Resolution of comments 242 and 267 on
Insertion loss measurements of installed fiber
cables

Steve Swanson
May 5, 2009

Current text in 86.10.1

1-jumper test configuration

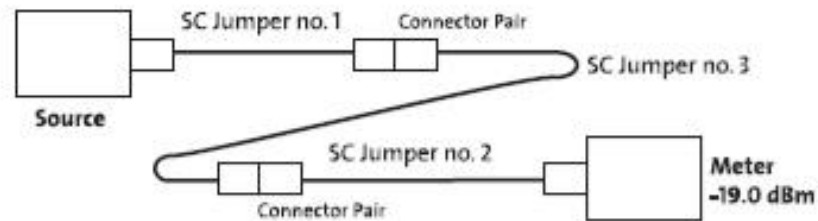
- Swanson comment 242
 - We need to allow both the 1 jumper method and the 3 jumper method for the measurement of insertion loss because field test equipment may not have the MPO connector.
- Coleman comment 267
 - Referenced 1 jumper method is restrictive as it requires usage of field test equipment with MPO connector interfaces. To my knowledge, field test equipment with a MPO interface is not commercially available now or in the near future. Recommend inclusion of the 3 jumper method to accommodate utilization of legacy and existing commercial field test equipment.

- The one-cord reference method includes the attenuation associated with connections at both ends of the cabling under test.
- The three-cord reference method attempts to exclude the attenuation of the connections of both ends of the cabling under test.
- The maximum allowed cabling attenuation specified (e.g. optical power budget or channel insertion loss) for a transmission system normally excludes the connections made to the transmission equipment.
- It is therefore appropriate to use the three cord reference method where the cabling under test is intended to be connected directly to transmission equipment.
- Either method can be used – adjustments are needed

- Either method can be used provided the results are adjusted to reflect what is being measured
 - For the 1-jumper method, the acceptance figure is adjusted down
 - For the 3-jumper method, the the acceptance figure is adjusted up
- 1-jumper is preferred if cable plant can be plugged directly to power meter (same connectors)
- 3-jumper is preferred if cable plant cannot be plugged directly to power meter (different connectors)
